**From:** Johnson, Nick M  
**Sent:** Monday, November 05, 2018 9:44 AM  
**To:** 'Krueger, Richard'  
**Cc:** Markegard, Glen  
**Subject:** RE: Preliminary Review - 8801 Lyndale Ave S

## CASE FILE #PL201800292

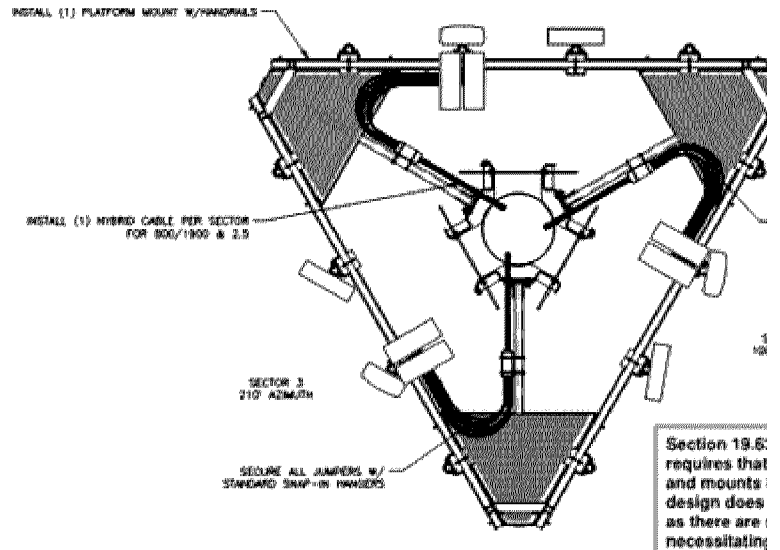
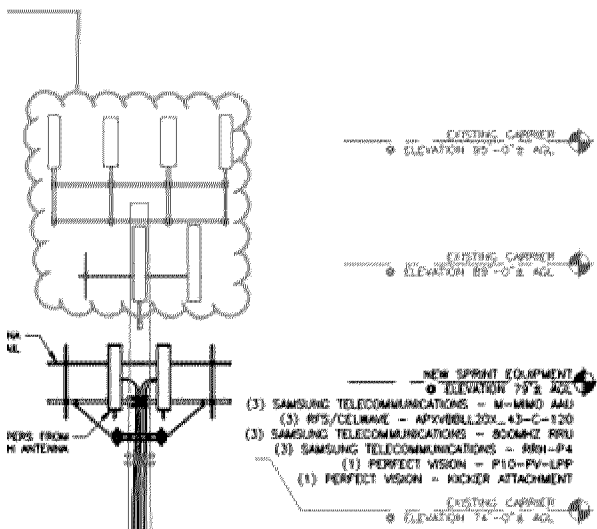
I think I am missing something. Forgive me. I don't see a substantive difference between the two plan sets. Here is the original equipment plan and tower elevation:

I do not see a substantive change with respect to visual impact. The plans appear to be nearly identical with exception of those struts you note. Please let me know if I am missing something.

It appears to me that the updated plans are still of a “crow’s nest” design with multiple unused mounts. As noted before, our ordinance focuses on minimizing visual impact. I do not believe these updated plans would adequately address our original concern. Please revise the plans to reduce the visual impact of the antennae mounts.

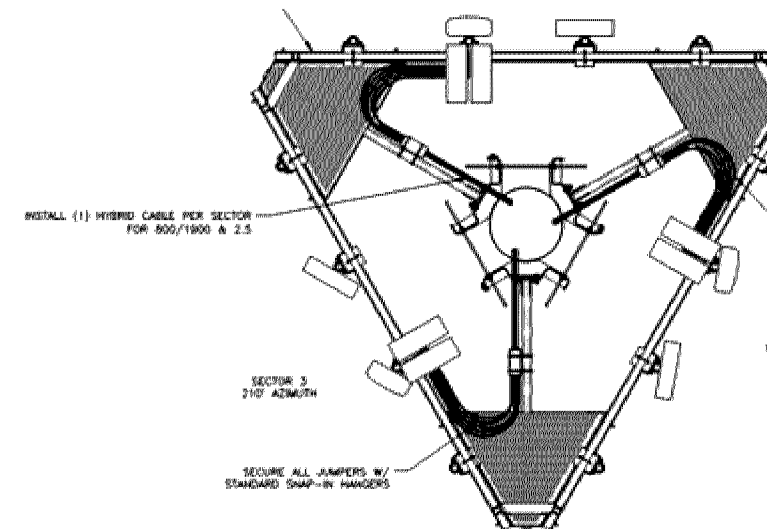
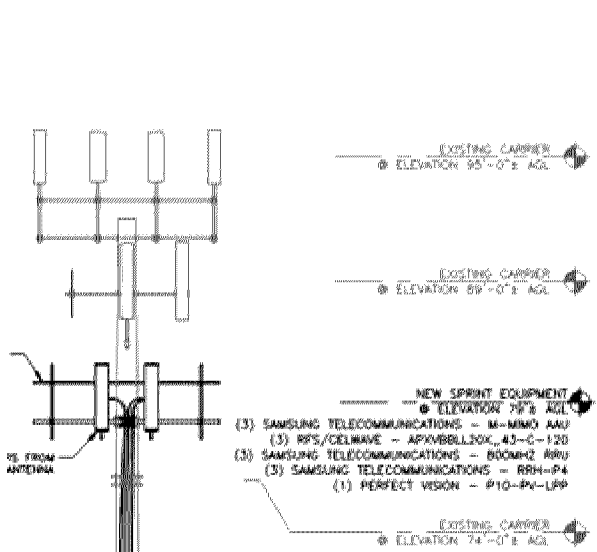
And here are the updated plans you sent me:

We changed the mount style as to not have any struts going in on a diagonal to the tower.

The antennas appear to be mounted near the top of the tower and therefore taller than the actual structure. Please see attached

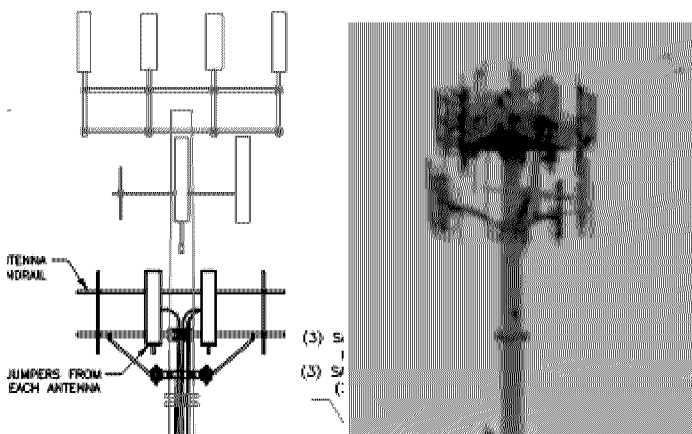
Also, I ask that the designer confirm that the existing height of the existing antennas is not being modified. The elevation drawings do not accurately reflect what is out there today according to images in streetview. See here:

As you can see, the elevation drawing shows the antennas extending far above the monopole tower, which is does not appear to be the existing condition.
